MORAY LOCAL REVIEW BODY

SUMMARY OF INFORMATION FOR CASE No LR257

Planning Application 20/01692/APP – Alterations and extension, dwelling house, 8 Moray Street, Hopeman

north sectional elevation

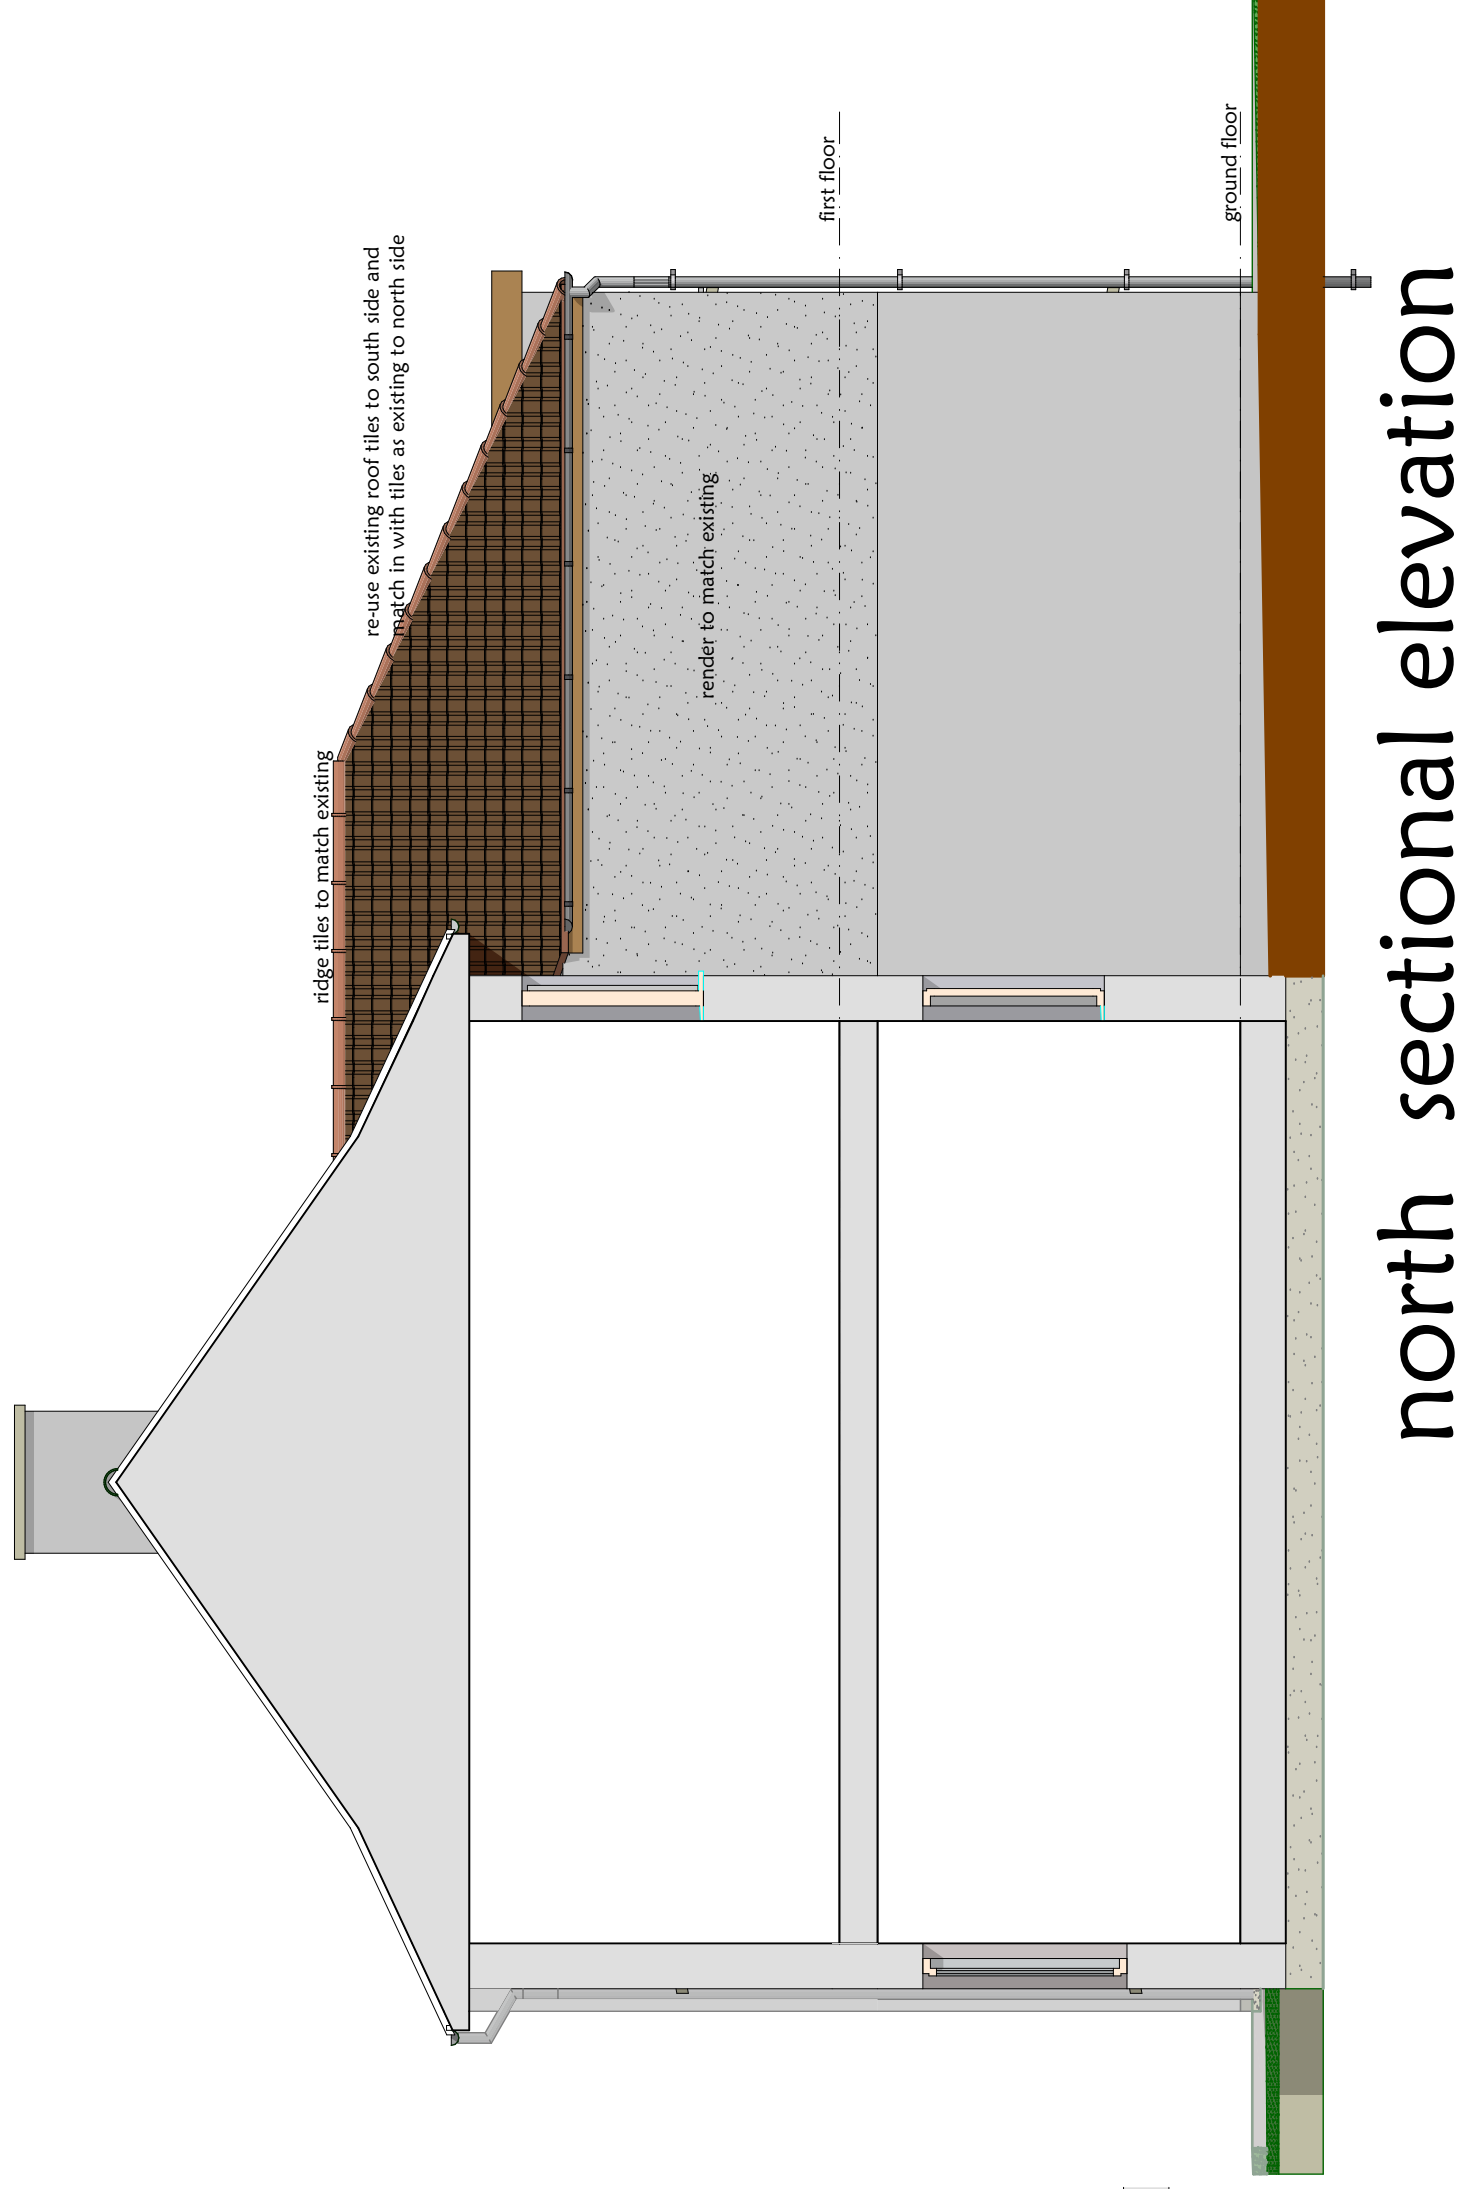
The original design of the extension measured approx. 6.2m x 4.5m x 7.6m (to the roof ridge, 5.m to the eaves) and incorporated a pitched roof. Following an initial review and site visit, concern was raised to the agent regarding the potential for the extension to give rise to an unacceptable level of overshadowing to the neighbouring (attached) property and in particular, the nearest neighbouring window which is believed to serve an open plan lounge/dining area. Following discussion with the agent, the design was altered to the current proposal which incorporates a hipped roof, a ridge height of approx. 6.1m and an eaves height of approx. 4.7m.

Although the overall height of the extension has been reduced by approx. 1.5m, the eaves height has only been reduced by approx. 0.7m. A BRE Information Paper on 'Site Layout Planning for Daylight'

sets out techniques which can be applied to assess developments for impact on levels of daylight. This does not form part of policy but is widely regarded as good practice. The guidance uses the 45 degree method for developments which are perpendicular to the window to be assessed. These techniques are only applied to 'habitable rooms' which would include all rooms designed for living, and sleeping. The method involves drawing a 45 degree line from the nearest corner of the proposed extension in both floor plan and elevation forms towards the neighbouring property. If the shape formed would enclose the centre point of a window on the neighbouring property, then the light to that window would be significantly affected. In the case of this proposal, a 45 degree line drawn on the floor plan from the south-western corner of the extension and on the elevation plan from eaves level to ground level would fully surpass the nearest neighbouring window on both plans and therefore would significantly affect the daylight to that window. It must be noted that the footprint of the proposed extension is unaltered from the existing single storey extension and therefore the 45 degree line on the floor plan would be the same across both the existing and proposed extensions. However the line drawn on the elevation plan would show a significant increase in overshadowing to the nearest neighbouring window than that on the existing rear elevation. This assessment demonstrates that there is already a degree of overshadowing from the existing single storey extension to the nearest neighbouring window (serving a lounge/dining area), however this would be increased by forming a first floor extension above the existing extension.

Policy DP1 states that proposals must not adversely impact upon neighbouring properties in terms of privacy, daylight or overbearing loss of amenity. The existing single storey extension has a large footprint (more than half of the original property) and a projection of 4.5m from the rear elevation and as a result would already affect the daylight to the nearest neighbouring window. The proposal to form a first floor extension above the footprint of the existing single storey extension would result in a increase in height (as measured from ground to eaves level) of 2.2m crease in wall height to form a first floor extension would result in an increased level overshadowing and decrease in daylight to the nearest neighbouring window. This would lead to an unacceptable loss of amenity to that property and therefore is unacceptable in terms of policy DP1.

Overall therefore, the proposed first floor extension, above the existing single storey extension would give rise to an unacceptable level of overshadowing to the nearest neighbouring property window (to the north of the site) which would lead to an overbearing loss of amenity to that neighbouring property and the application will be refused.

The planning officer raised the issue of overbearing with me, I discussed with the applicants and we reduced the height of the eaves by 750mm, the pitch by 10 degrees and the ridge considerably by 1550mm, or just over 5ft, (see drawing numbers 34:2020:1b and 2b) We felt that this was a satisfactory outcome in that the overall scale has been reduced by 1550mm and the wall head height is below that of the neighbours windows on the first floor; allowing the south and south west sun.
